Docket Item # 6  
DEVELOPMENT SPECIAL USE PERMIT #2001-0004  
TABLE TALK RESTAURANT SITE

Planning Commission Meeting  
March 5, 2002

**ISSUE:** Consideration of a request for a development special use permit extension for construction of an office building.

ATTACHMENT 2

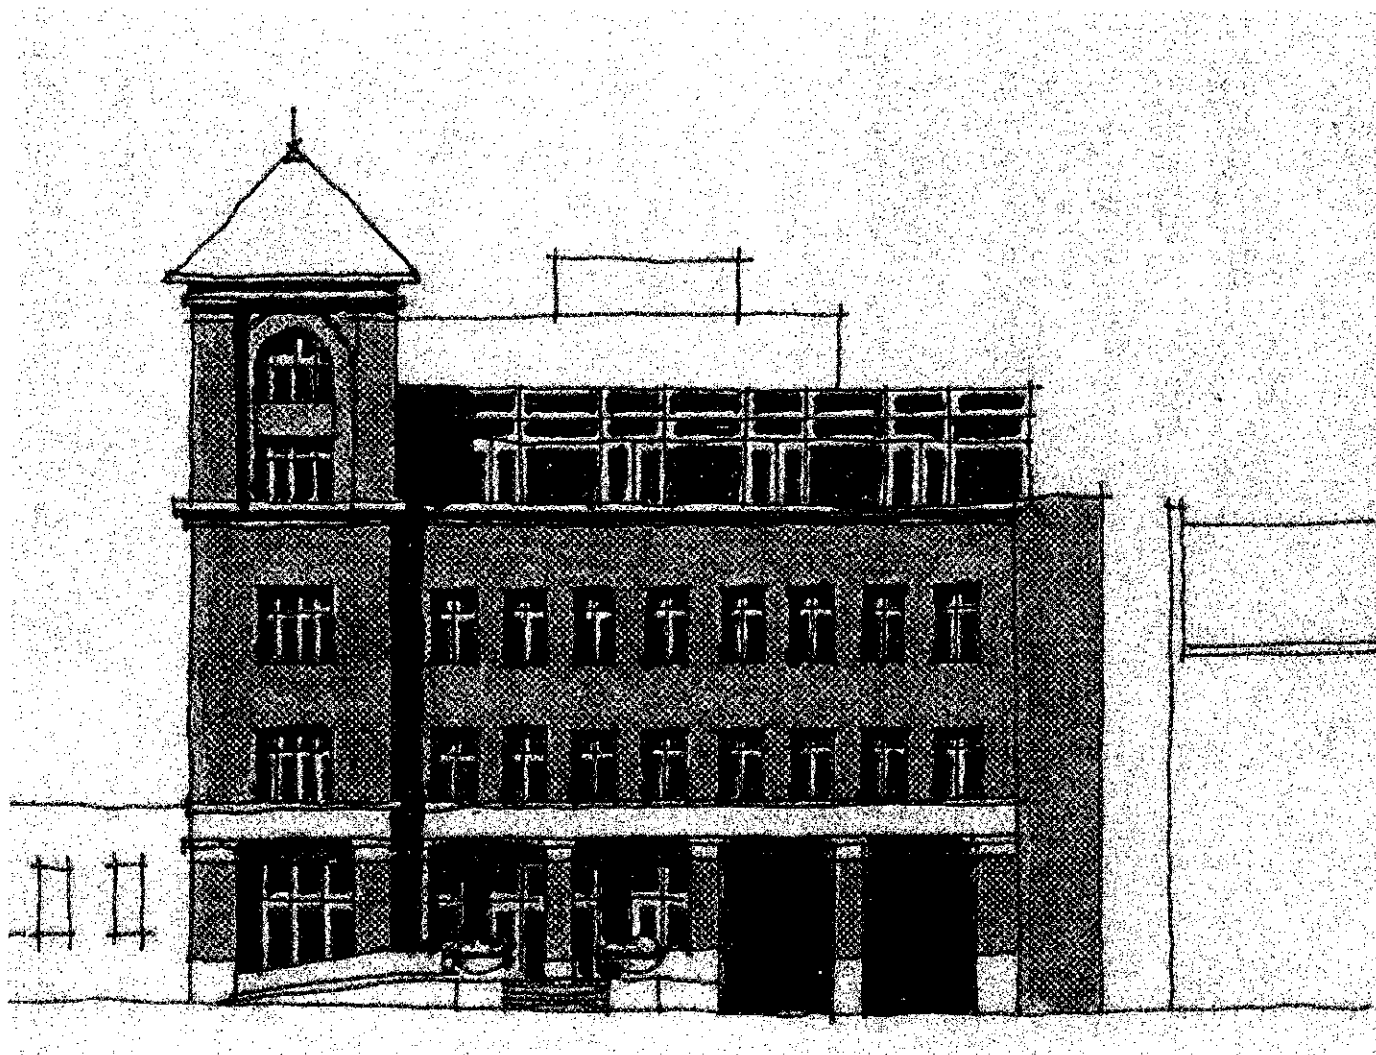
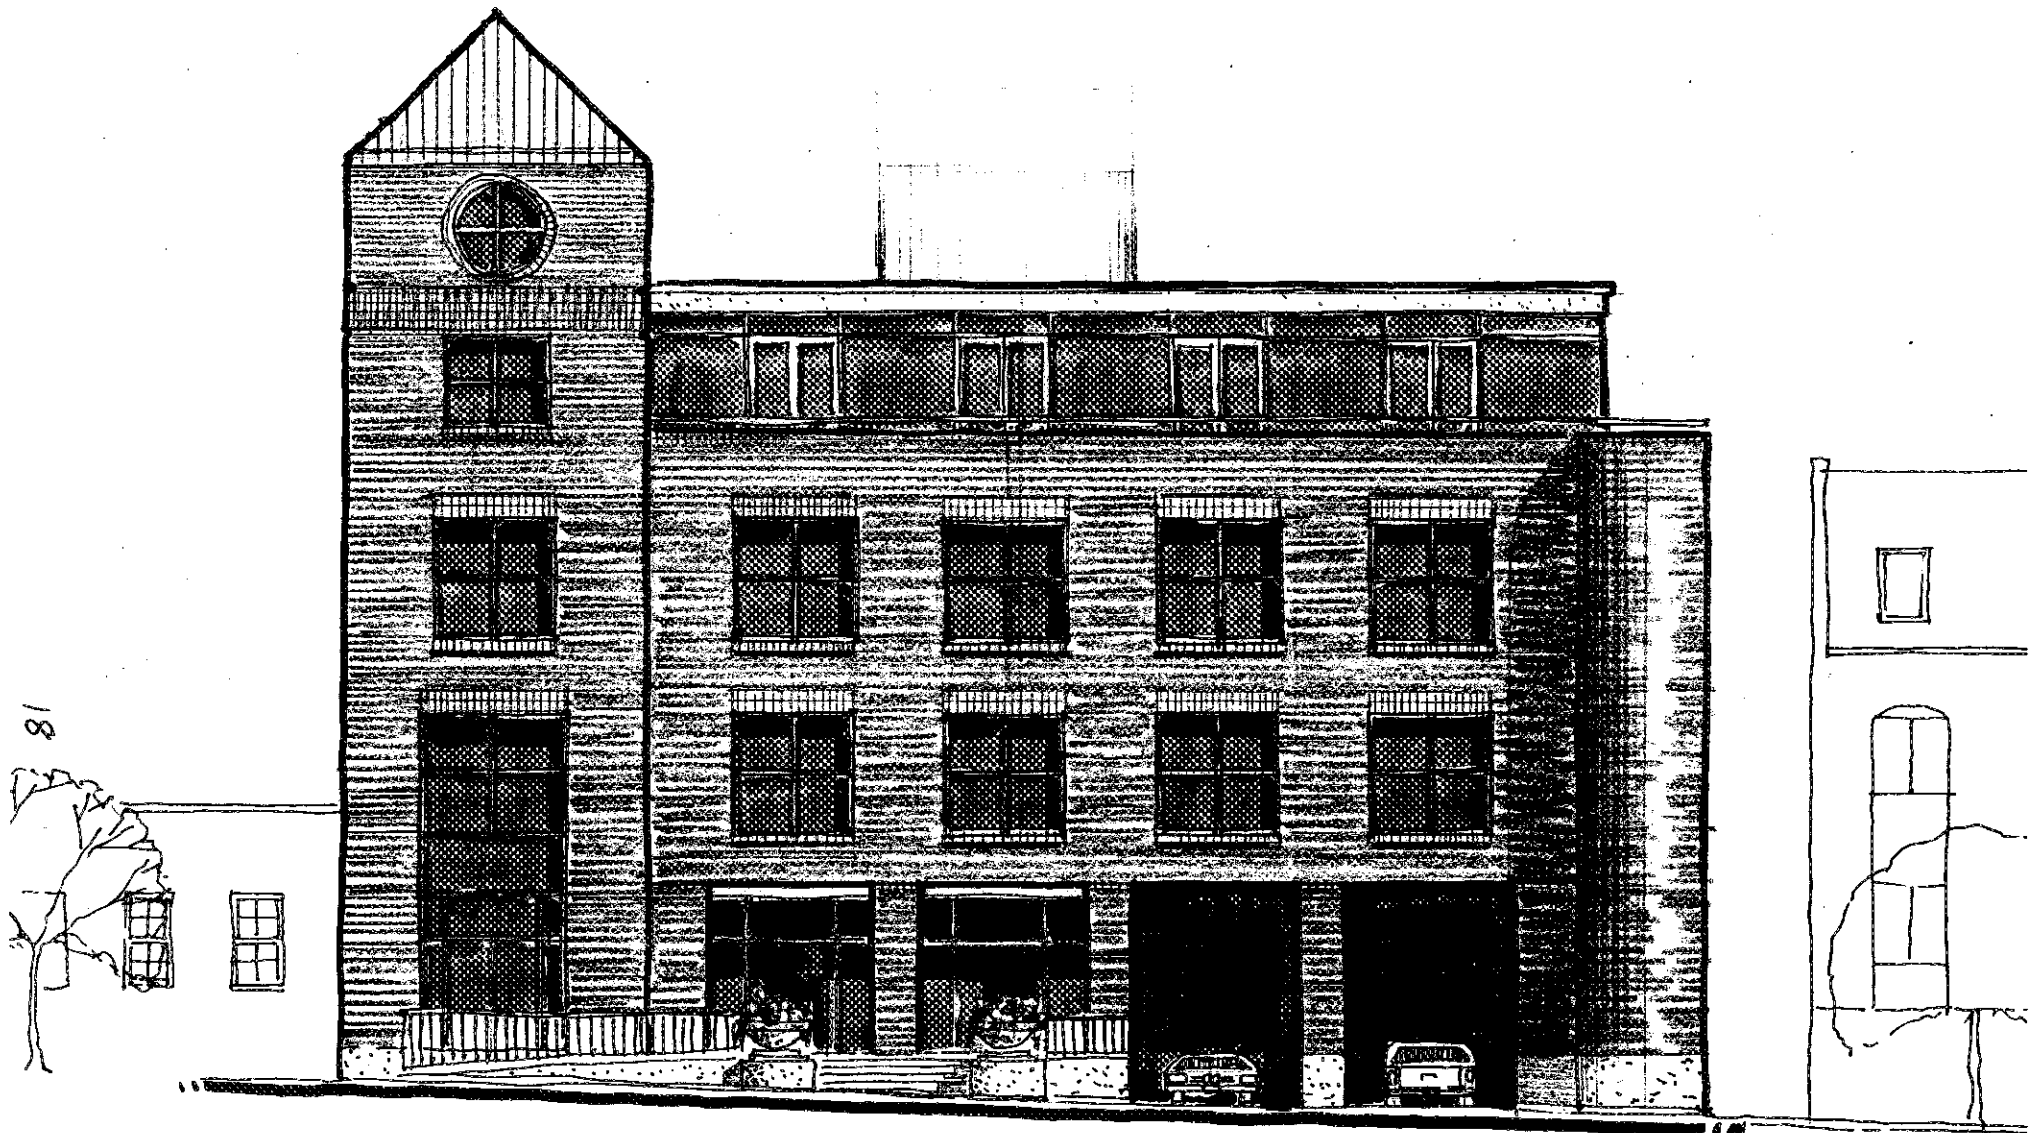
Staff has included several sketches of building facade design treatments incorporating these elements (as illustrated in Attachments 1 through 3). The applicant's last modification shown in Attachment 4 is a significant improvement over the original proposed design treatment as illustrated in Attachment 5, but there are still several design elements that do not fully satisfy staff's recommended design guidelines. At issue is the design of treatment of the windows, appearance of a two story arcade and roof top treatment to screen mechanical equipment. The remaining design issues are:

- a) Treatment of window sills and headers is too simplistic, lacking sufficient size to define the window opening and visually reduce the size of the windows to provide a transition between the large window openings and the building facade.

- b) Use of a contrasting material band between the first and second floor which gives the appearance of a two-story arcade which staff has identified as being of an inappropriate pedestrian scale for a building of this mass and scale.

- c) Need for additional window mullions within the window glazing to break down the scale of the windows to be more in character with the traditional punched window treatment found on other buildings in the King Street area.

- d) Redesign of the tiered roof top screening which negates the transparency of the top floor and produces a heavy roof top appearance. The top floor is set back and consists primarily of exterior glazing making it appear to be a less visible element on the building. However, the tiered roof treatment creates a massive appearance atop the roof, visually bringing the top floor back into visual prominence along the skyline of the building. Screening of roof top mechanical equipment should consist of lighter less obtrusive materials that are of a scale and mass that is the minimum necessary to screen the roof top mechanical equipment.

Mr. Hart agreed that the building facade design treatment depicted in the staff sketch Alternative 3 (Attachment 3) of the staff report was acceptable to the applicant.

24. **NEW CONDITION:** Modify the proposed building design to meet the following design guidelines to the satisfaction of the Director of P&Z:
  - a. Respond to the site's visually prominent location on axis with Holland Lane by providing high quality materials and detailing on the south facade with a strong architectural focal point, a highly modeled facade and an articulated skyline.

2. Regarding the detailing:

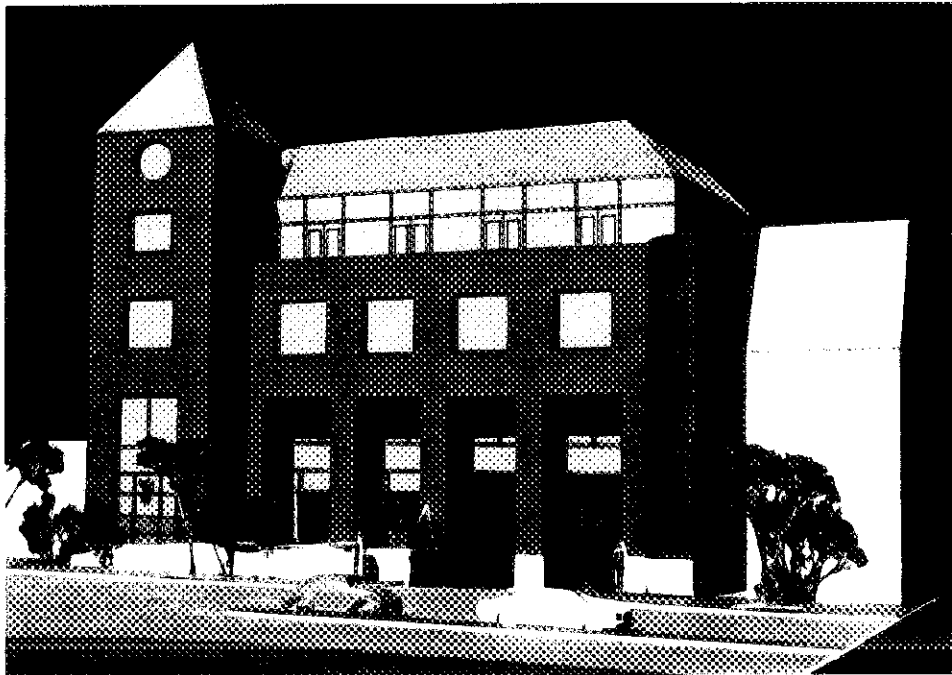
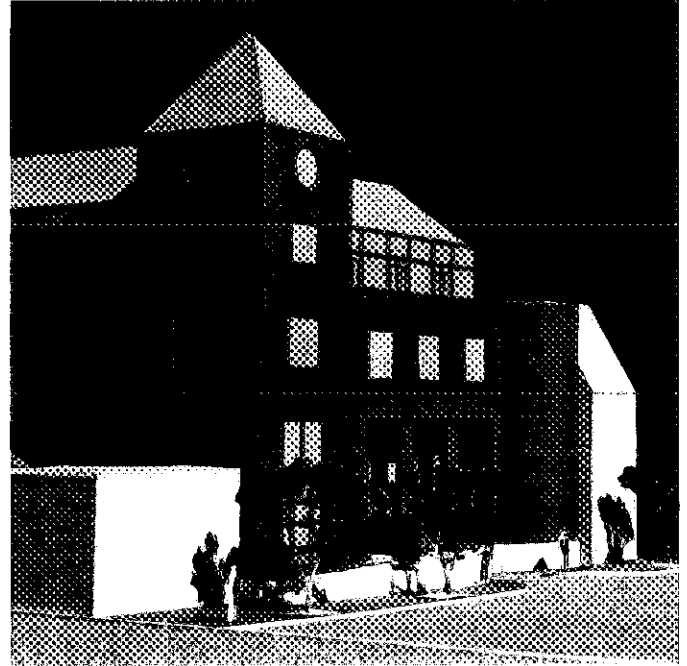
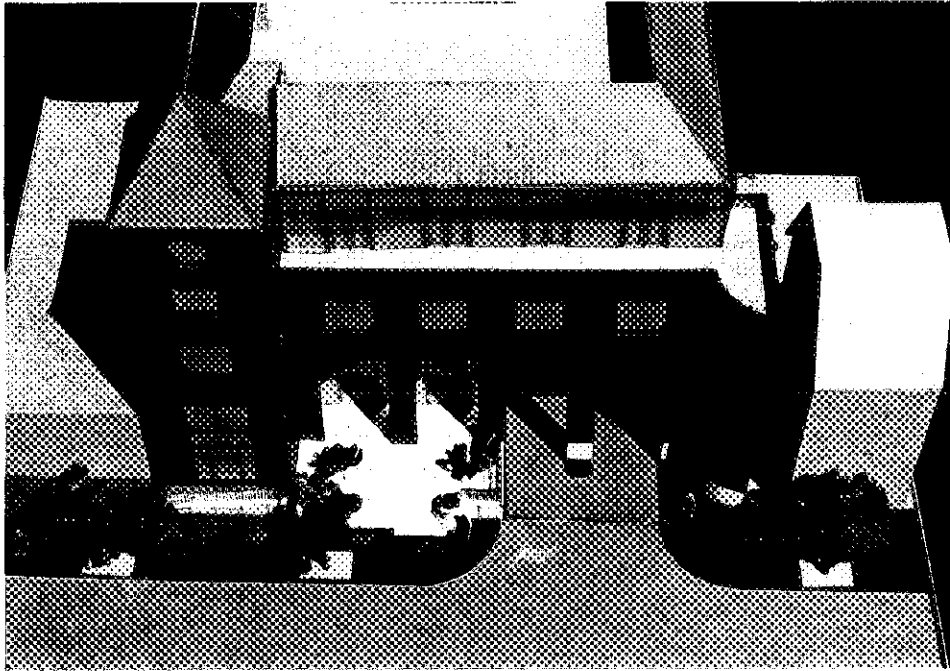
We feel that our building should not match the detailing of the Carr project because it is separated by the future development of the Hooff building and is located at a different site along Duke Street. Providing bases and capitals and wall cornices and smaller more vertical windows with muntins, lintels and sills unnecessarily complicates and reduces the impact of the facade as designed, which can be clearly seen on the model which we presented to the reviewers during our meeting of July 9th.
